# Service Bulletin

Ref. No. **2XD-0116 (P058)**

<b>Subject:</b>	<b>Corrective measure for service call C2840 (Change of primary transfer unit)</b>		
<b>Model:</b>	TASKalfa MZ7001ci, TASKalfa MZ6001ci, TASKalfa MZ5001ci, TASKalfa MZ4001ci, TASKalfa MZ3501ci, TASKalfa MZ2501ci, TASKalfa MZ7001i, TASKalfa MZ6001i, TASKalfa MZ5001i, TASKalfa MZ4001i, TASKalfa 7054ci, TASKalfa 6054ci, TASKalfa 5054ci, TASKalfa 4054ci, TASKalfa 3554ci, TASKalfa 2554ci, TASKalfa 7004i, TASKalfa 6004i, TASKalfa 5004i, TASKalfa 4004i, TASKalfa 6053ci, TASKalfa 5053ci, TASKalfa 4053ci, TASKalfa 3553ci, TASKalfa 3253ci, TASKalfa 2553ci, TASKalfa 6003i, TASKalfa 5003i, TASKalfa 4003i, TASKalfa 6052ci, TASKalfa 5052ci, TASKalfa 4052ci, TASKalfa 3552ci, TASKalfa 3252ci, TASKalfa 2552ci, TASKalfa 6002i, TASKalfa 5002i, TASKalfa 4002i, ECOSYS P8060cdn, ECOSYS P4060dn		
<b>Classification :</b>	<b>Field measures timing:</b>	<input type="checkbox"/> At Set Up <input checked="" type="checkbox"/> Next Visit/Service Call	<input type="checkbox"/> Next Periodic Maintenance <input type="checkbox"/> Information only

Primary transfer unit

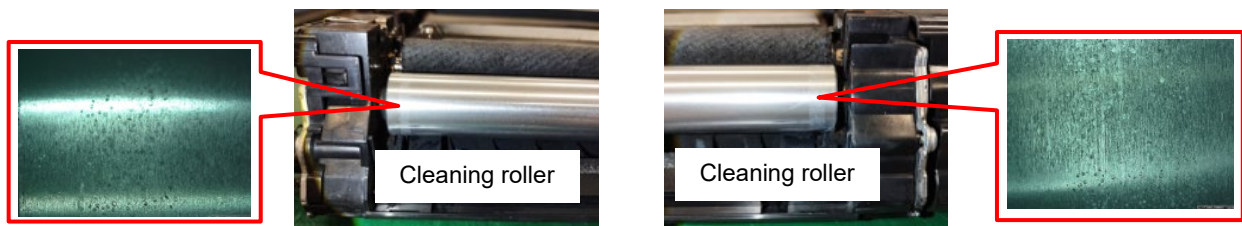
When the cleaning blade inside the primary transfer unit rolls up and the driving torque increases, a service call error C2840 (Belt cleaning motor error) might occur. Therefore, the following changes are made.

Due to scratches (pinholes: see figure below) on the surface of the cleaning roller, a load might be applied to the cleaning blade, causing it to roll up. Therefore, the anodized coating thickness on the surface of the cleaning roller is increased. Coating thickness change: 7μm --> 14μm.

**Field Measure:** If the above phenomenon occurs, please replace the part with a new part.
